10/784,895

Marcel Mathijs Theodore Marie Dierichs

Office Action Summary

DETAILED ACTION

Pierrat - Figure 2

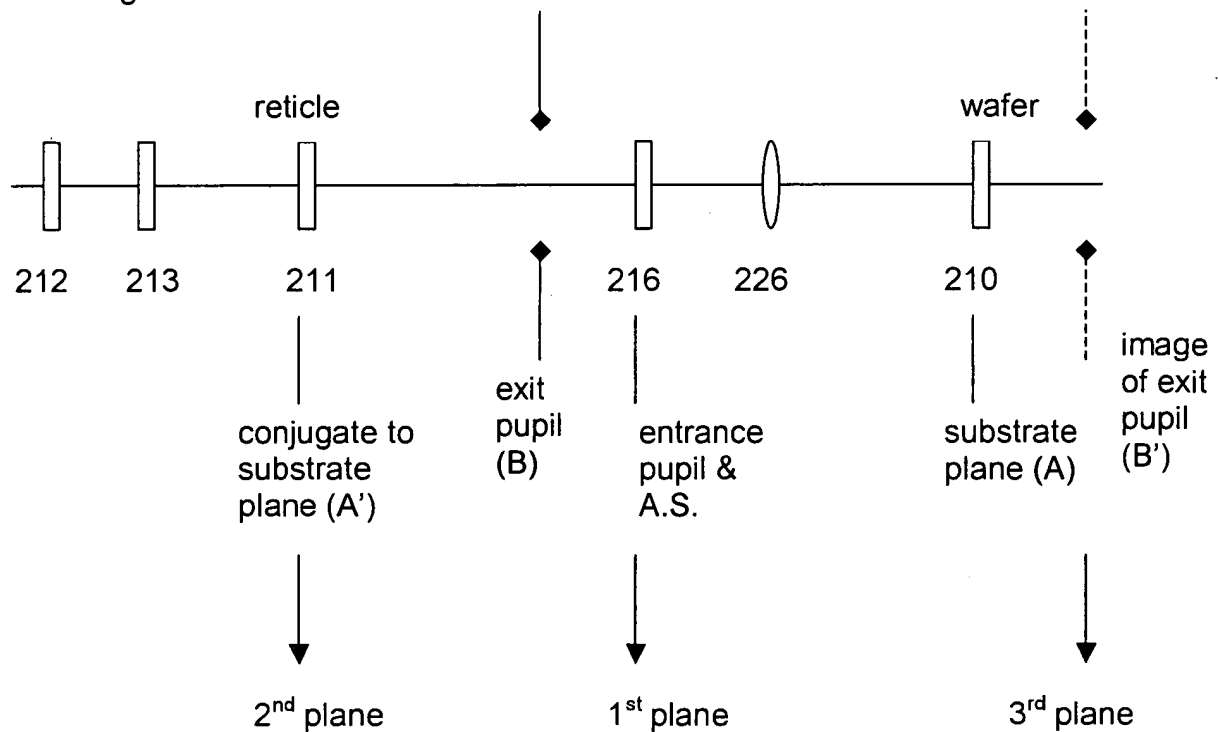
Regarding the 35 U.S.C. 102(b) rejection of claims 1 and 12 as being anticipated by Pierrat (US 6,040,892), the applicant makes the argument that "as clearly shown in Figure 2 of Pierrat, the aperture blades 216, 218, 220 and 222 are clearly positioned in a plane prior to the projection optics 226 and the wafer 210. Therefore, the aperture blades are not in a first plane that is intermediate a second conjugate to a plane of the wafer 210 and a third plane conjugate to the pupil pane of the projection optics 226."

For proper imaging in any optical system, the reticle (211) is located at a conjugate plane to the wafer (210). Thus, the "2nd plane" is conjugate to a plane of the

substrate. Given that the aperture (216) is located before the lens (226), the aperture will act as the aperture stop and as the entrance pupil of the lens. Further, the exit pupil will be located to the left of the aperture. (See Hecht, Optics, p. 150) An image of the exit pupil utilizing the lens (226) would result an image located to the right of the lens. Therefore, a conjugate plane to a pupil plane of the projection system is located to the right of the aperture. Thus, the examiner maintains that Pierrat does disclose " a device positioned in a first plane intermediate a second plane conjugate to a plane of the substrate and a third plane conjugate to a pupil plane of the projection system."
